TRANS/WP.29/GRE/2001/31/Rev.2
19 January 2004

PROPOSAL FOR DRAFT AMENDMENTS TO REGULATION No. 48

(Installation of lighting and light-signalling devices)

Transmitted by the expert from the Working Party "Brussels 1952" (GTB)

"Annex 10

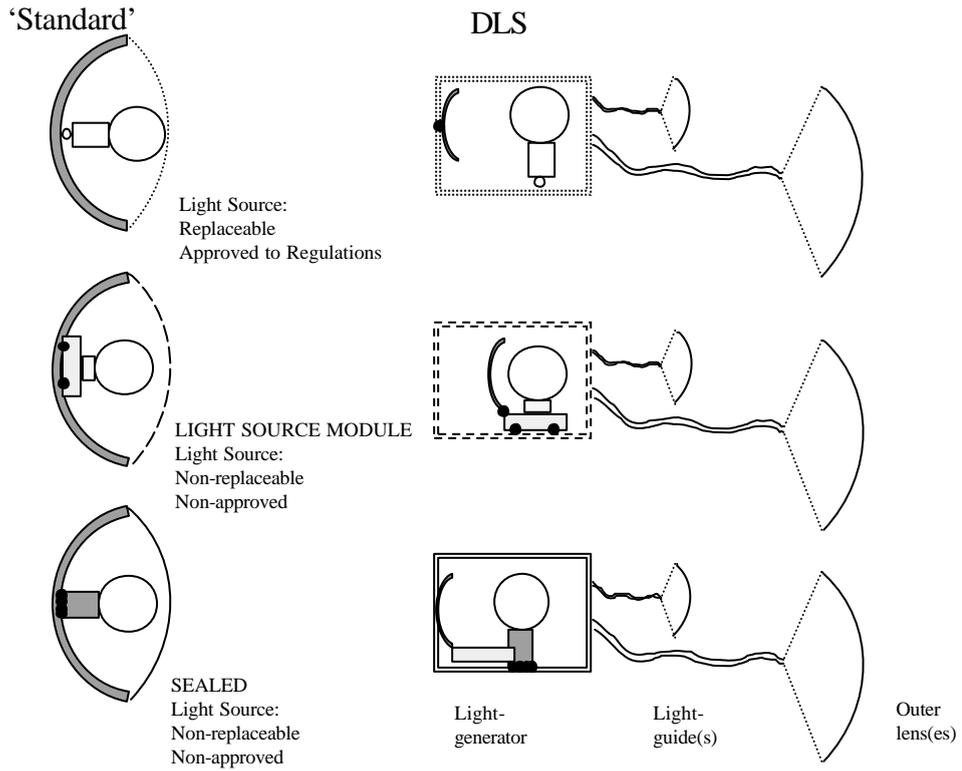
Insert a new annex 10, to read:

EXAMPLES OF LIGHT SOURCE OPTIONS
